City Council Special Meeting Agenda

Approve Change Order #1 for the Beacon Hill Water Tank and Water Main Extension Project

Change Order

Project: BEACON HILL WATER TANK & WATER MAIN EXTENTION PROJECT	Owner: City of Cody, Wyoming	Owner's Contract No.: 2020-01
Contract: Beacon Hill Water Tank & Water Main Extension Project		Date of Contract: May 4, 2020
Contractor: Harris Trucking & Construction, Inc.		Engineer's Project No.: 171133

SANDSTONE BENCHING LAYOUT
BEACON HILL WATER TANK & WATER MAIN EXTENSION PROJECT

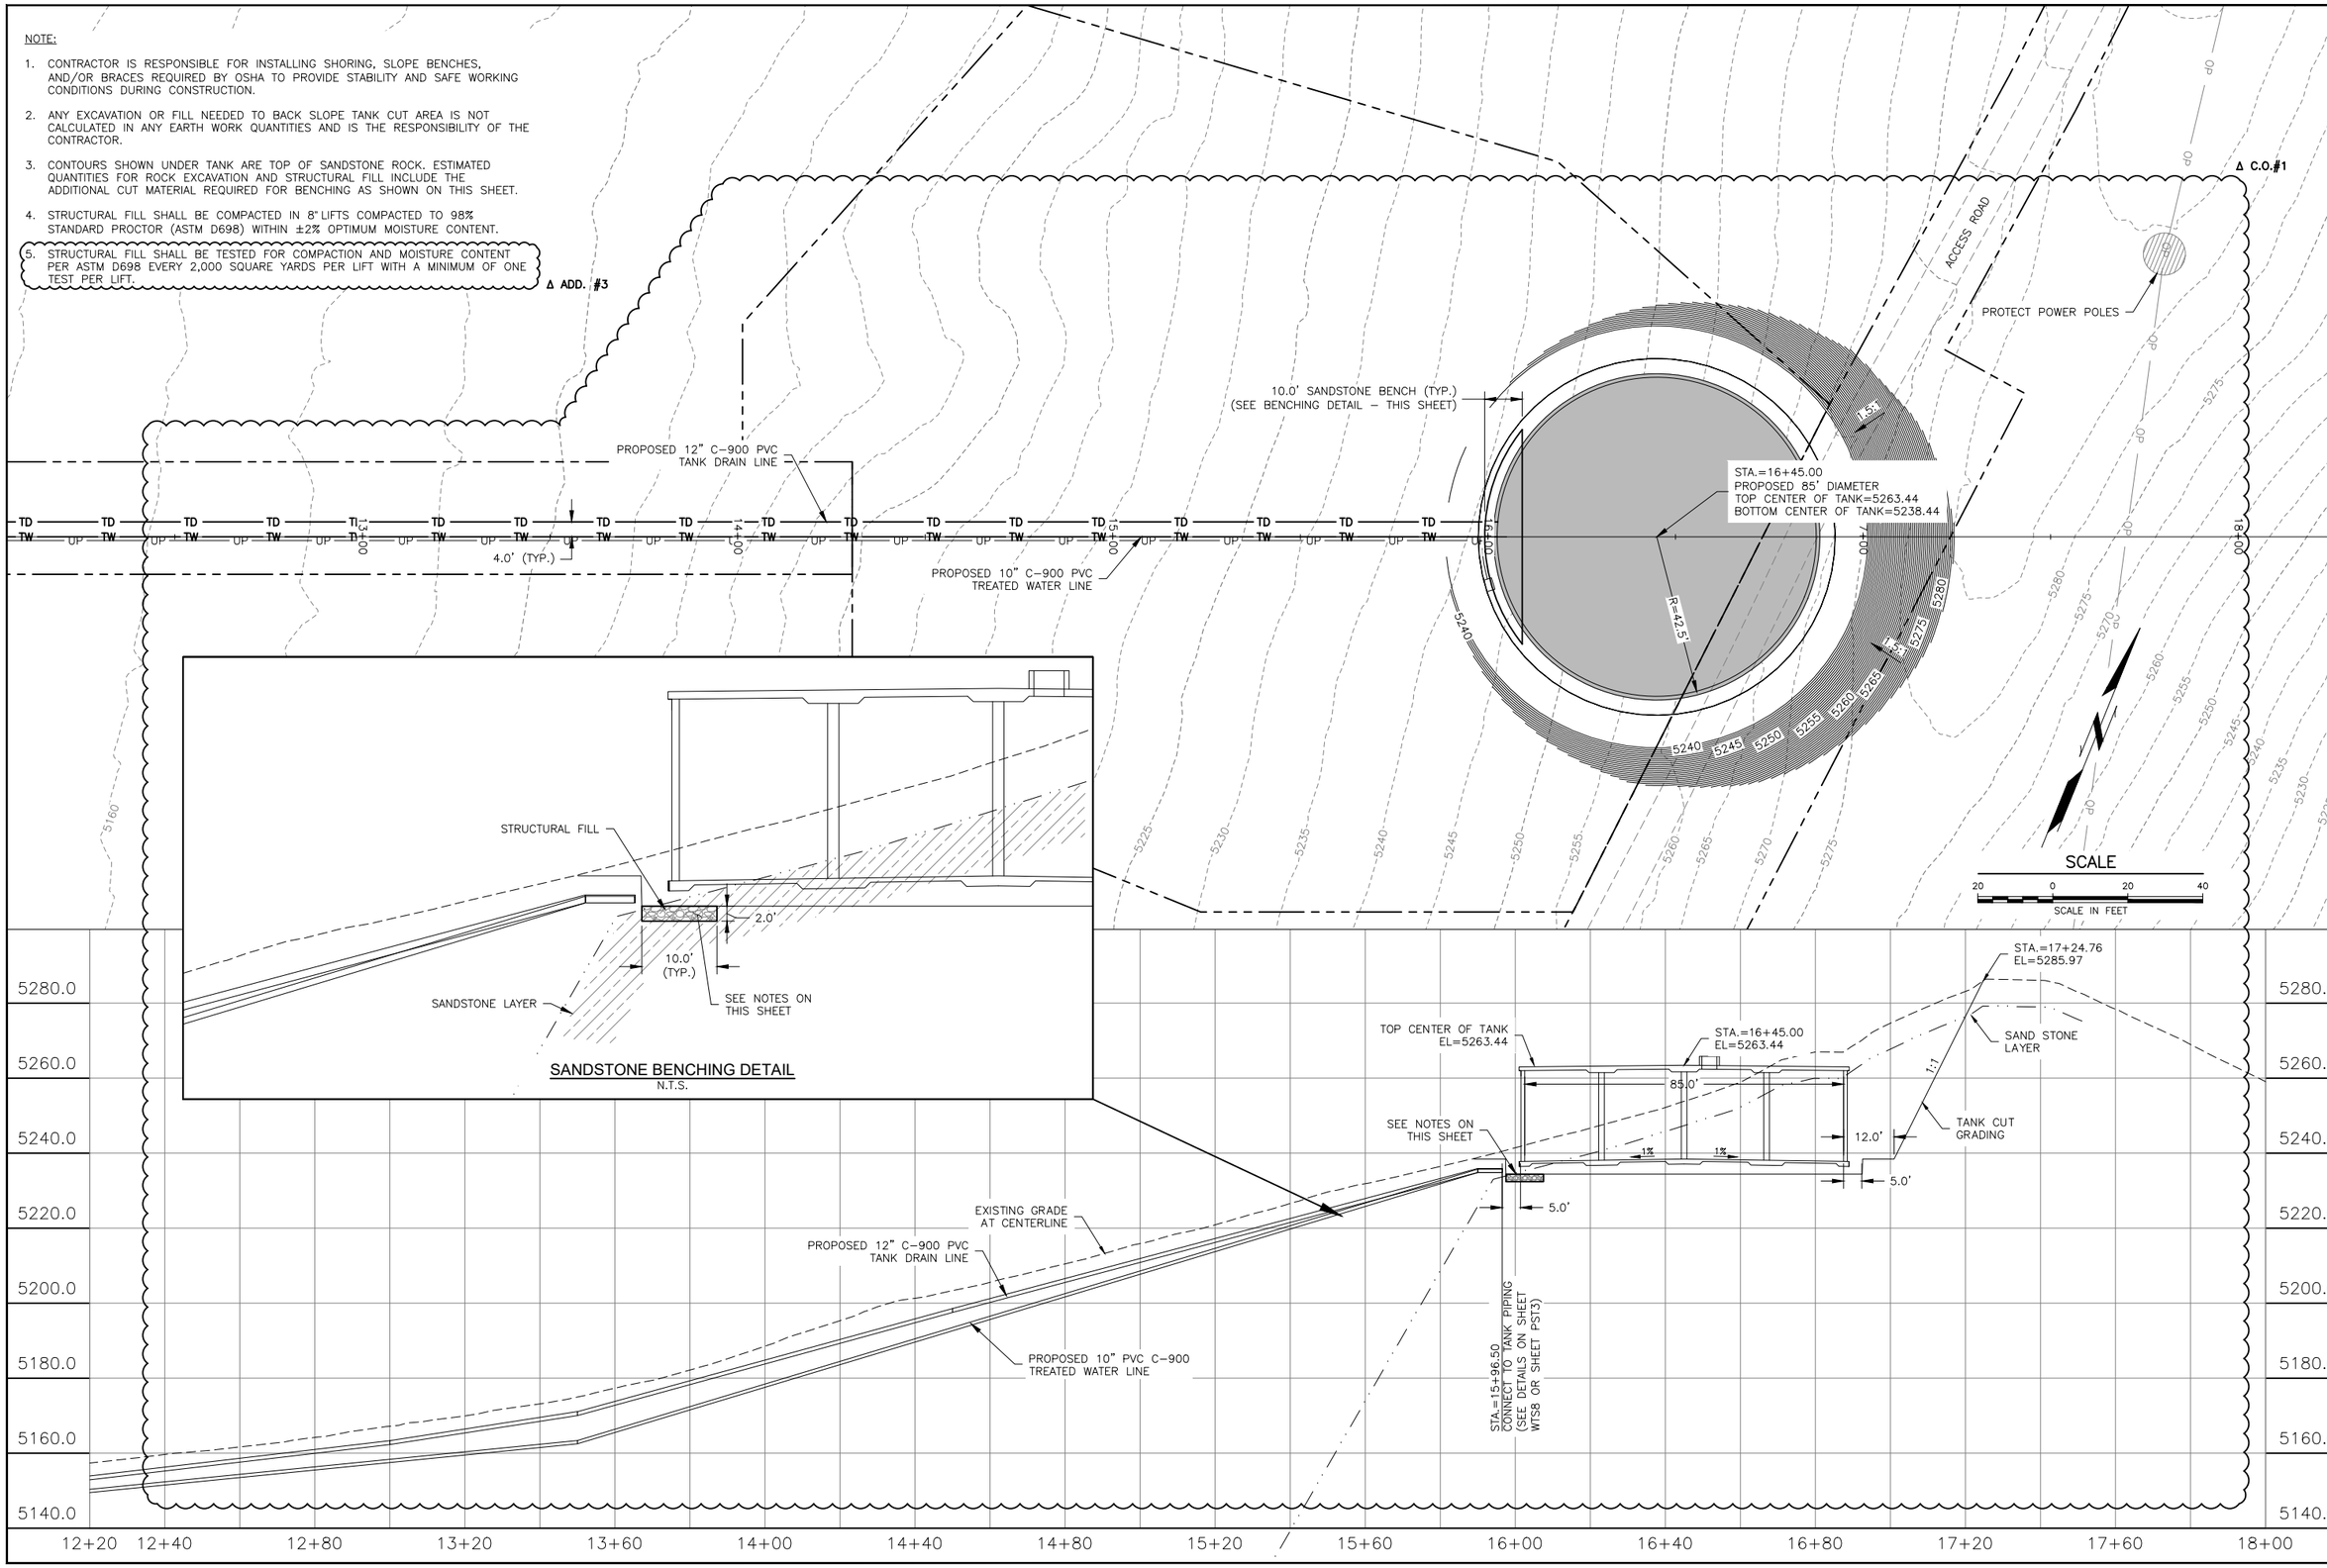
NO.	DESCRIPTION	DATE	BY
2	CHANGE ORDER #1	6/18/2020	TJI
1	ADDENDUM #3	05/11/20	ABK
